GENERAL

This addendum forms a part of the Contract Documents and modifies the original Bidding Documents dated February 2024 and consists of pages AD1-1 through AD1-3, PSSB Data As-Built and PSSB RCP As-Built. The following changes, additions and/or deletions shall be made to the following documents; all other conditions shall remain the same.

ITEM NO. I – RFI/CLARIFICATIONS

PATIENT SUPPORT SERVICES BUILDING
 UCD PROJECT NO. A/C 934990

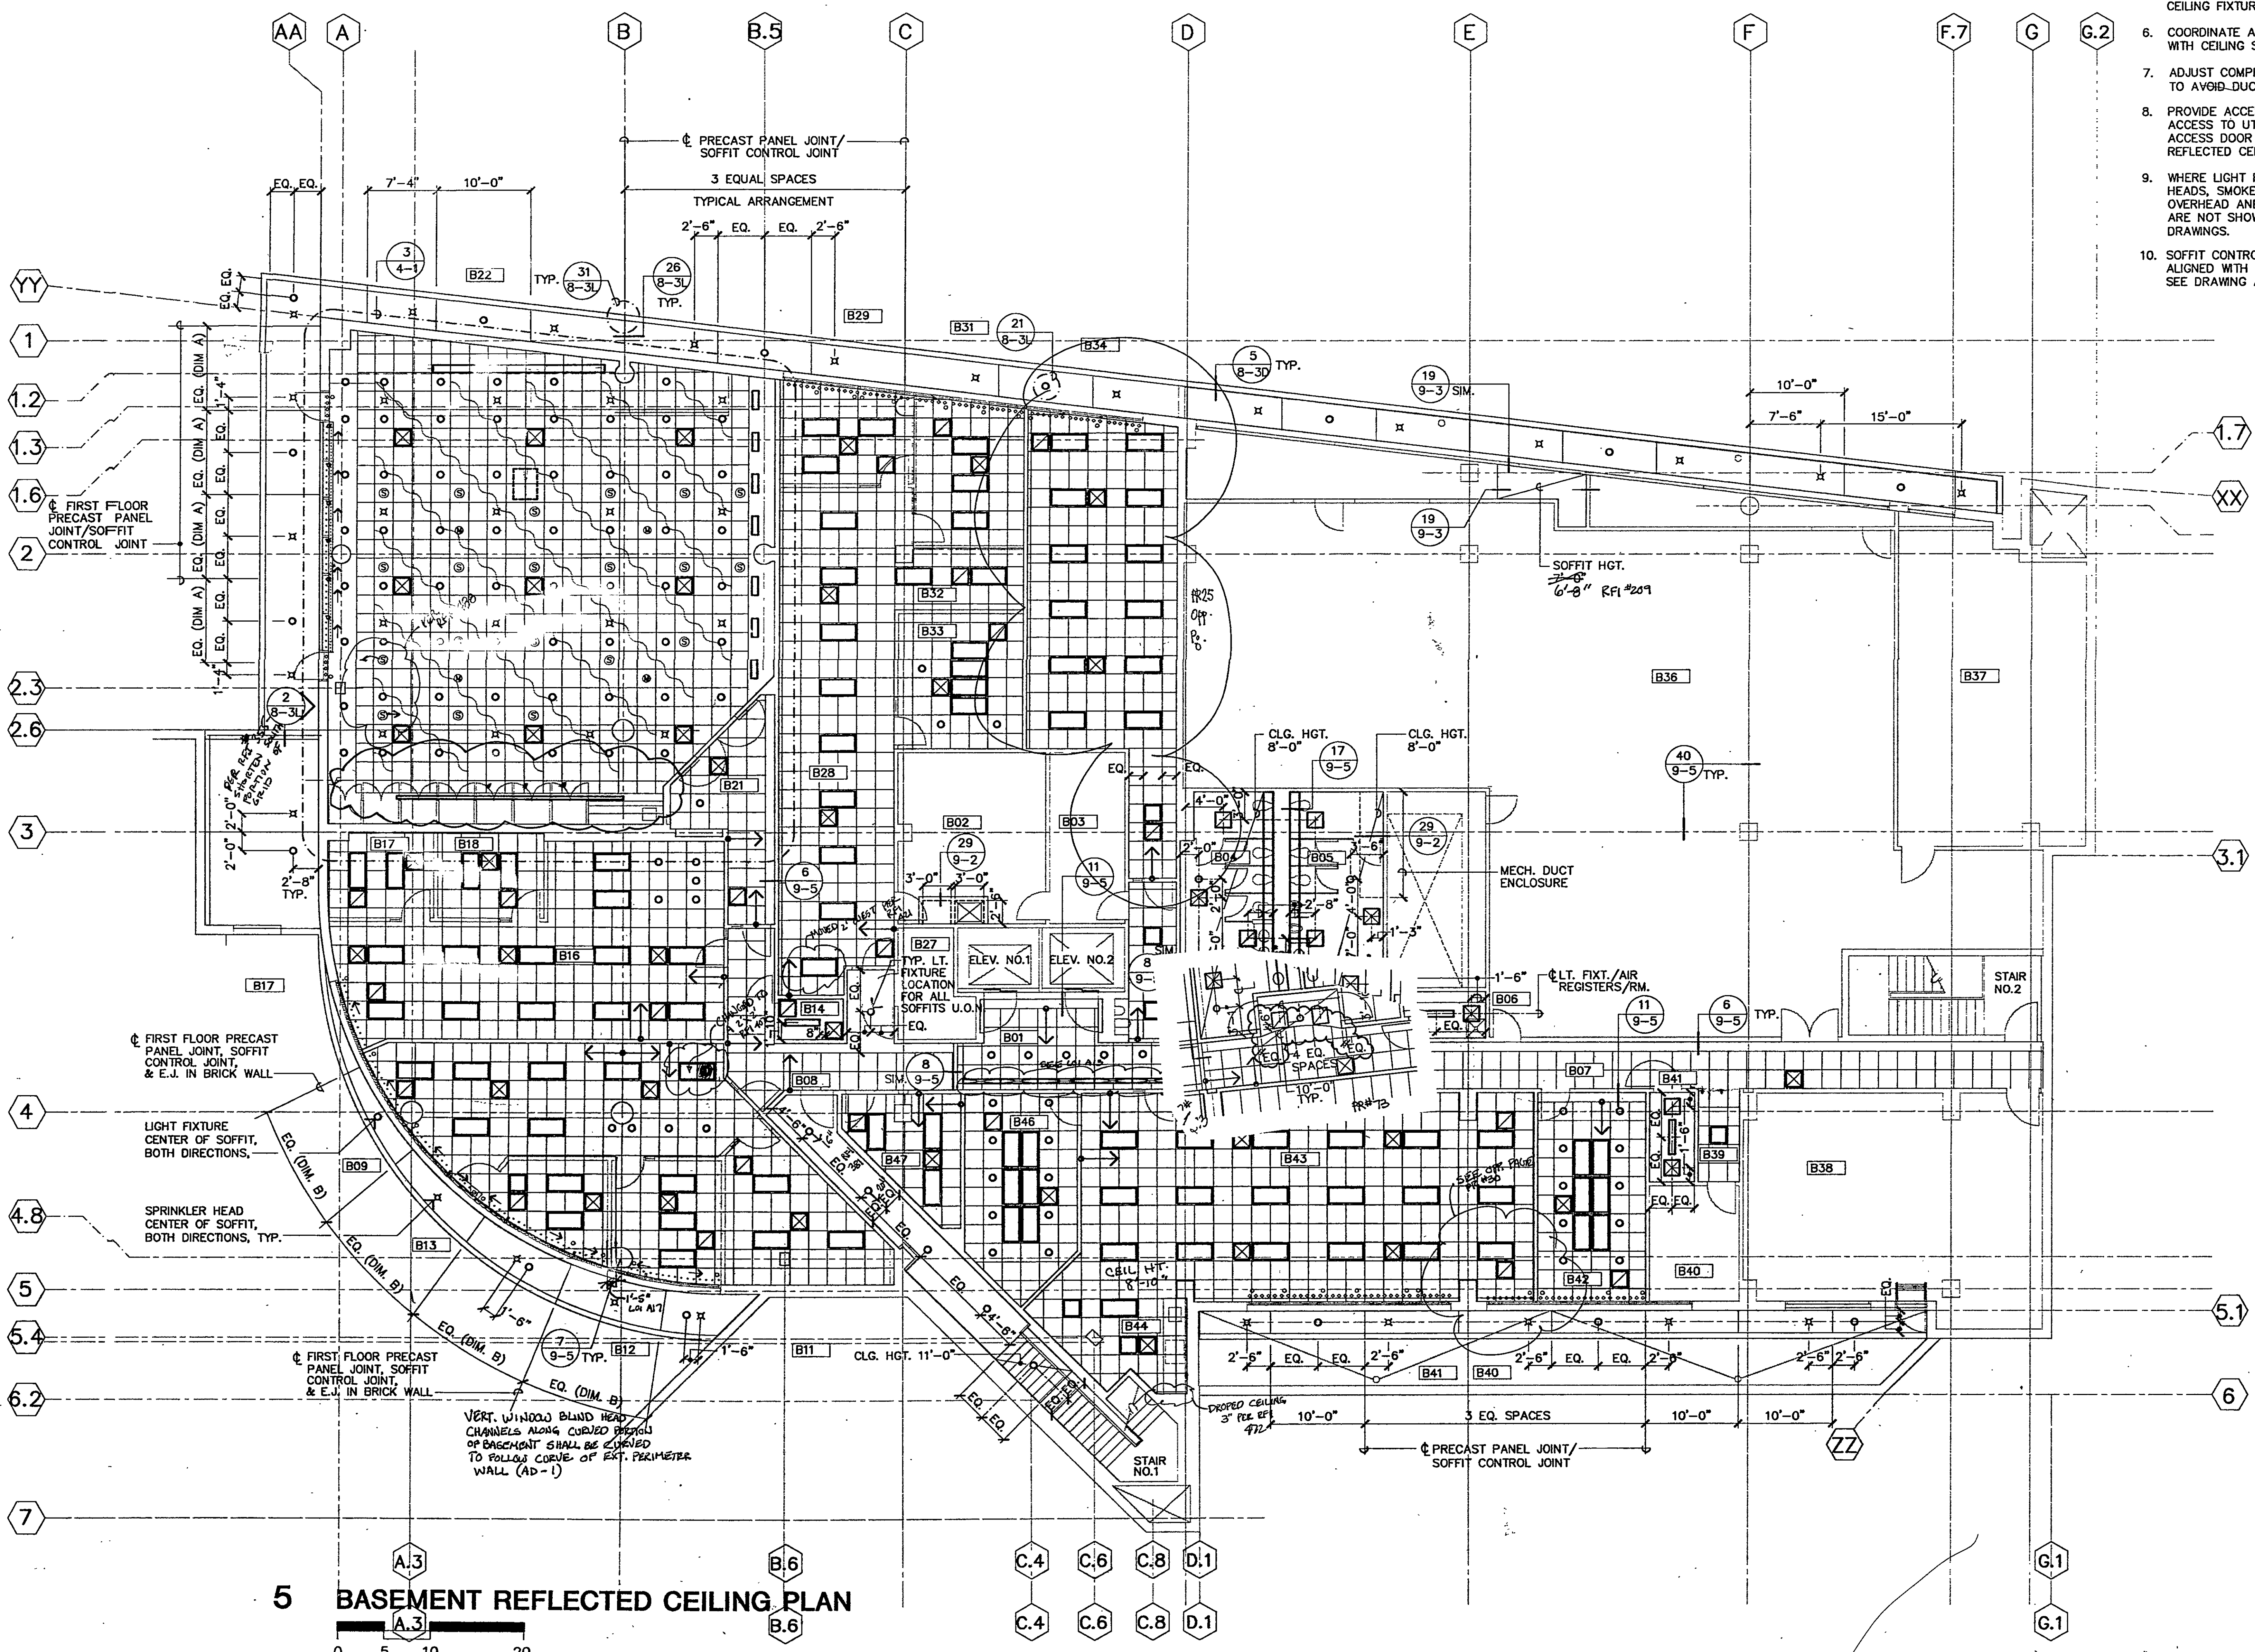
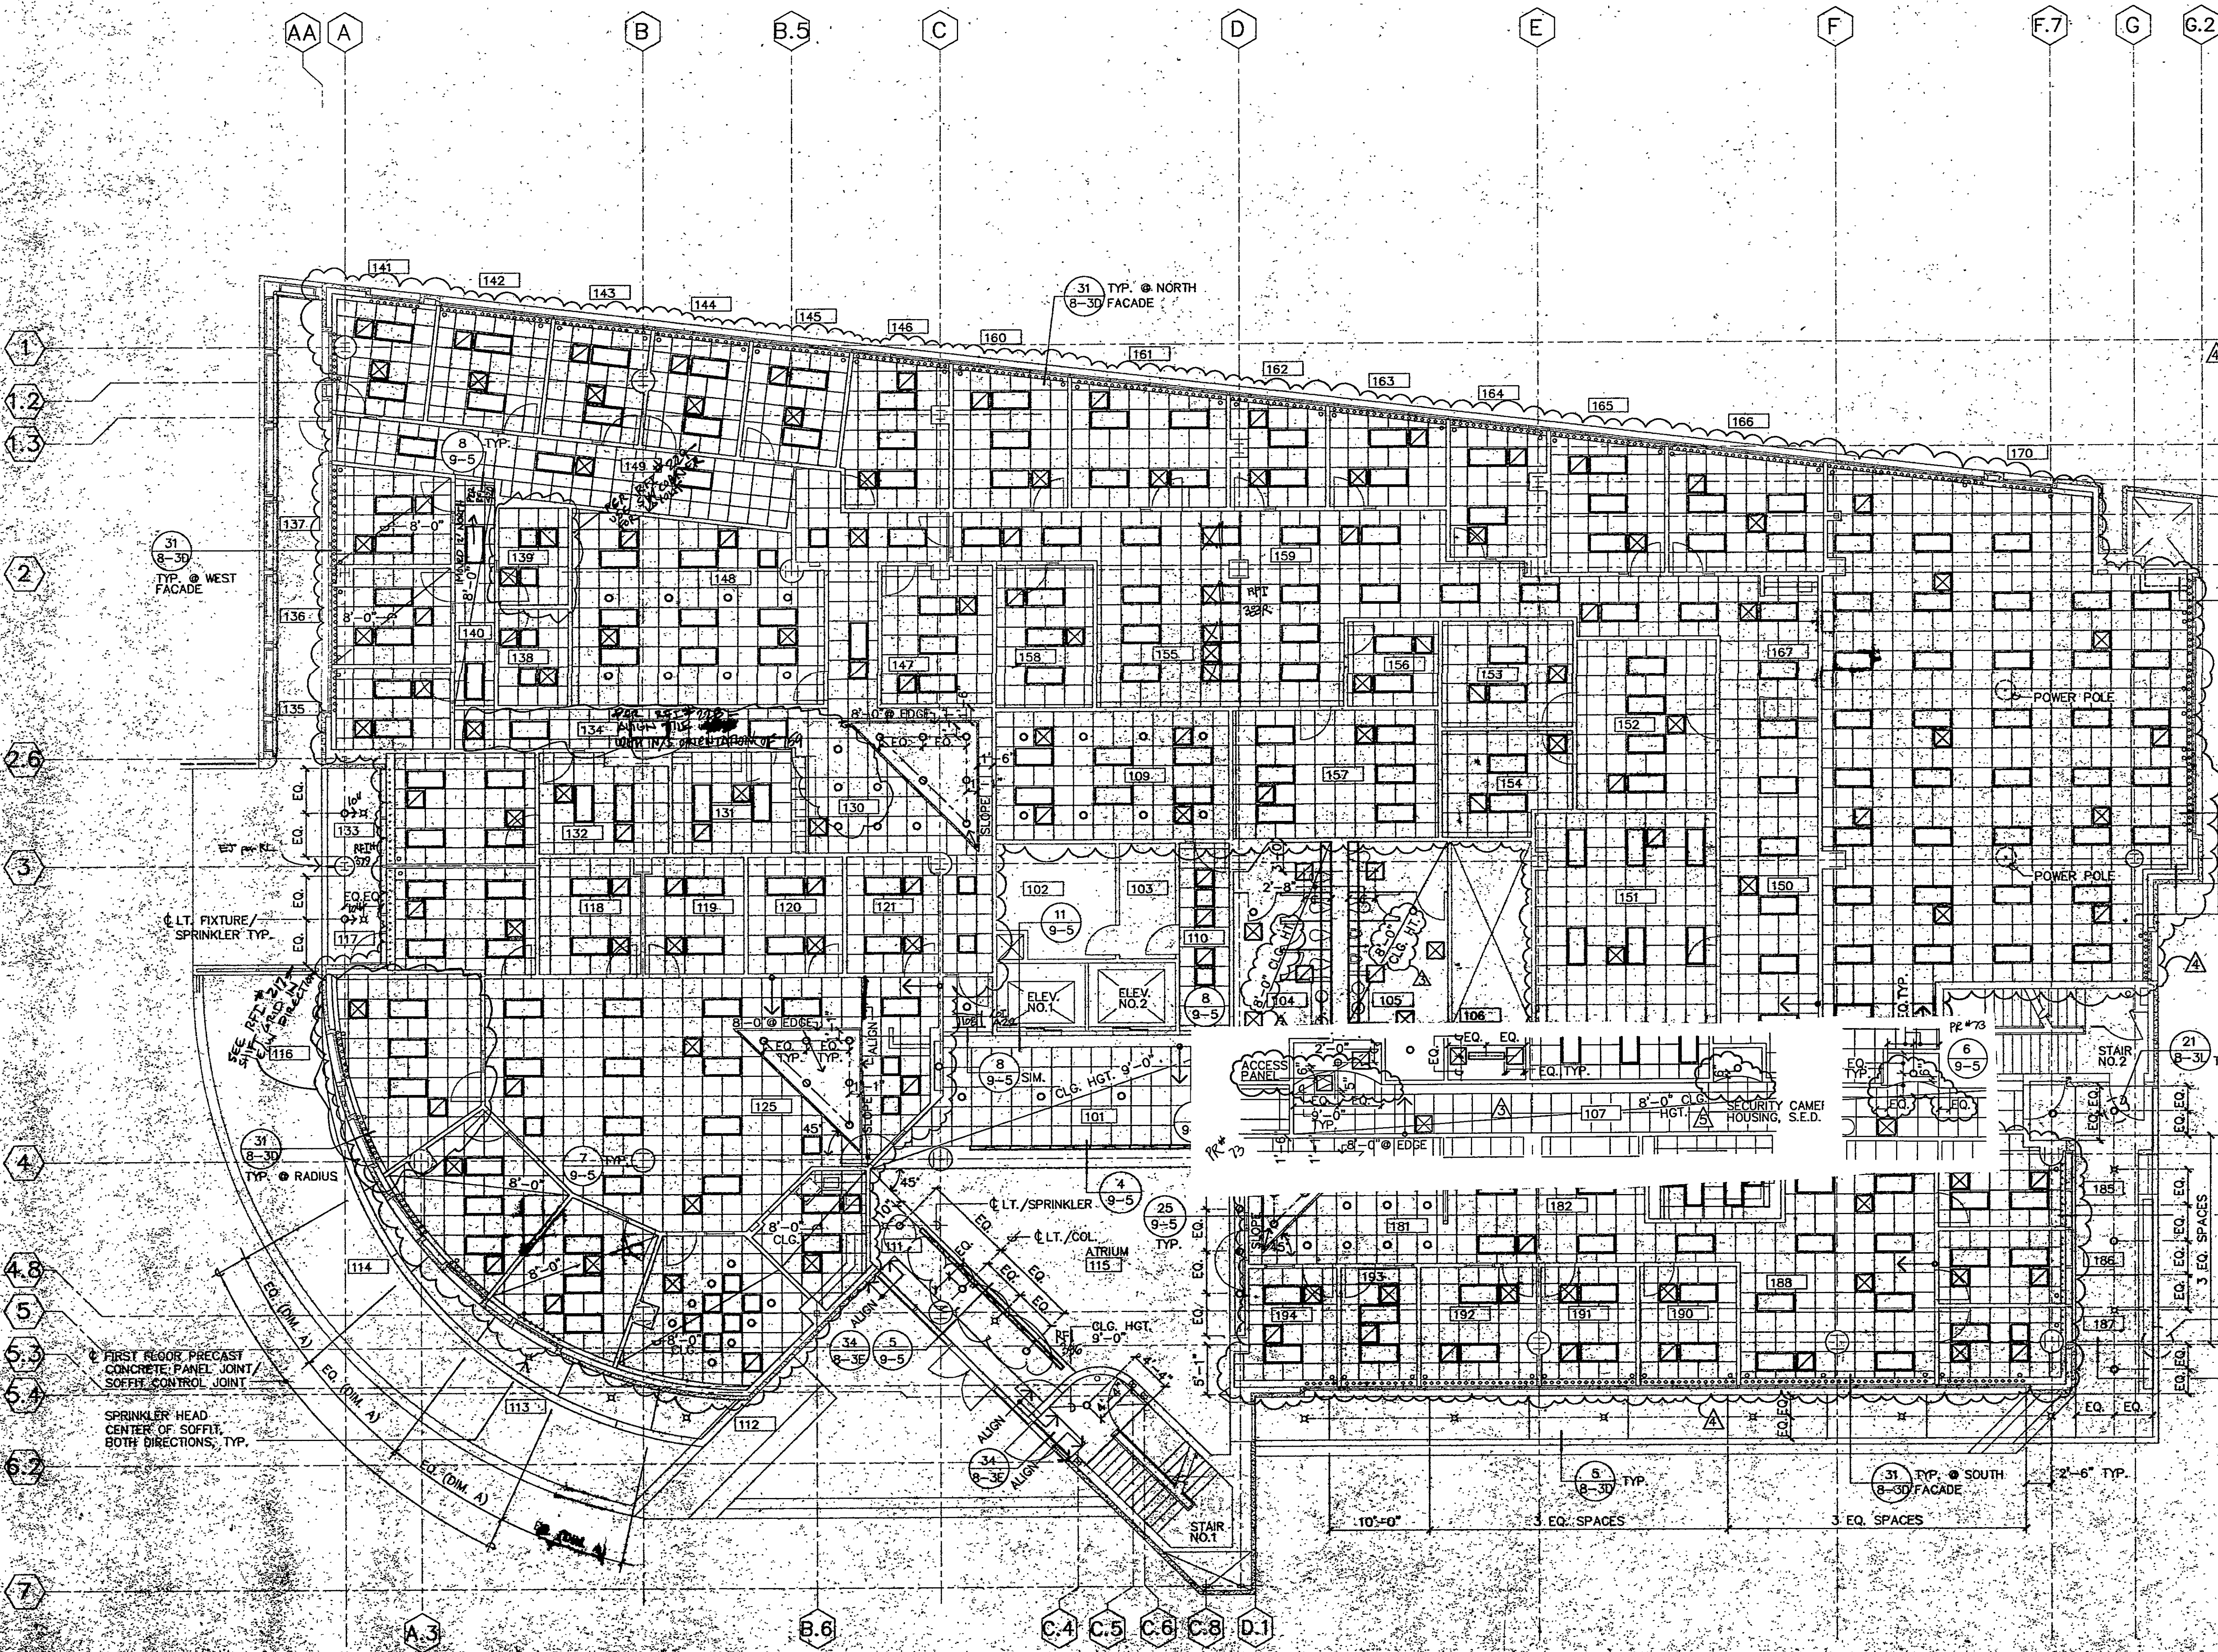
17. **Question:** Please confirm the ceilings on each floor are drop tiles in the areas where we will be required to access the ceiling.

18. **Question:** Please confirm the ceiling height on each floor is not higher than 15'.

Answer: See attached as built reflected ceiling plans. There are limited areas where a hard lid ceiling is present.

Answer: Confirmed. Caveat being the entryway atrium space. See reflected ceiling plan as built files for to reference extent of atrium space.
